SSD-8586218 – TEMPERATURE CONTROLLED WAREHOUSE FACILITY SECTION 4.55(1A) MODIFICATION APPLICATION

The modification relates to the installation of signage, alterations to the office forecourt/amenity area and a minor increase in GFA on site. This application identifies the consent, describes the proposed modifications, and provides an assessment of the relevant matters contained in Section 4.55(1A) of the EP&A Act. This application is accompanied by architectural drawings prepared by SBA Architects (**Attachment A**) and Landscape Plans prepared by Site Image (**Attachment B**).

Figure 1 Indicative Plan for Large Flush Wall Sign

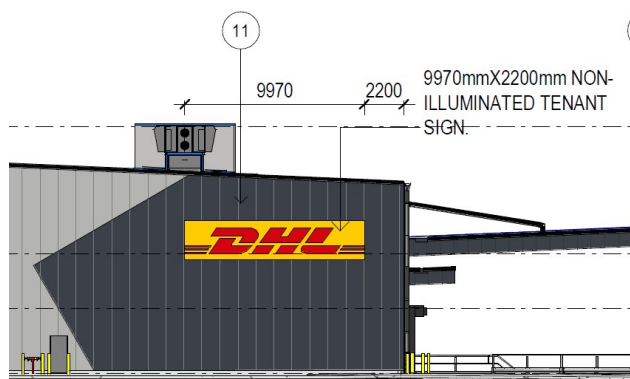
This modification seeks approval of business identification and directional signage at the site. Specifically, approval is sought for the installation of five (5) flush wall signs and four (4) free-standing pylon signs.

The flush wall signage will include the logo and branding of the tenant operating at the site being DHL. Four pylon signs will include the logo and name of the estate operator ESR.

The design of the signage is straightforward and comprises the logo and branding elements of the tenant and estate operator to assist in business identification and wayfinding. A summary and numerical breakdown of the proposed signage is provided in **Table 1**. Excerpts from the Architectural Plans depicting the proposed signage and locations have been provided in **Figures 1-3** below.

Figure 4 Level 1 Floor Plan

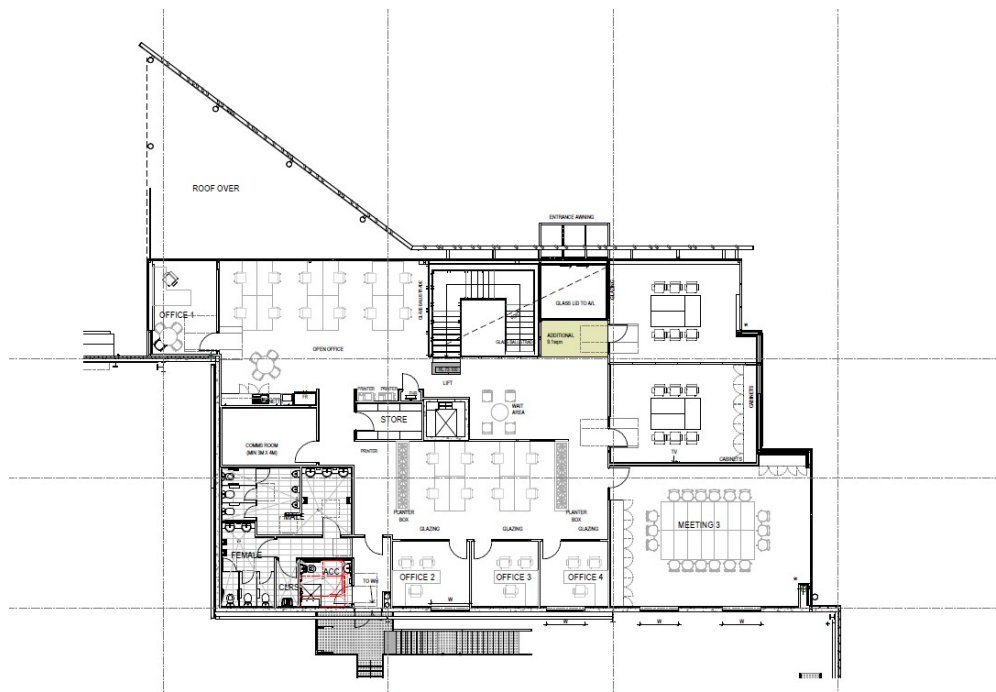
The modification seeks approval for an additional 9.1m² of floor area on Level 1 of the office (refer **Figure 4** below). The additional GFA is needed to facilitate amended access to meeting rooms.
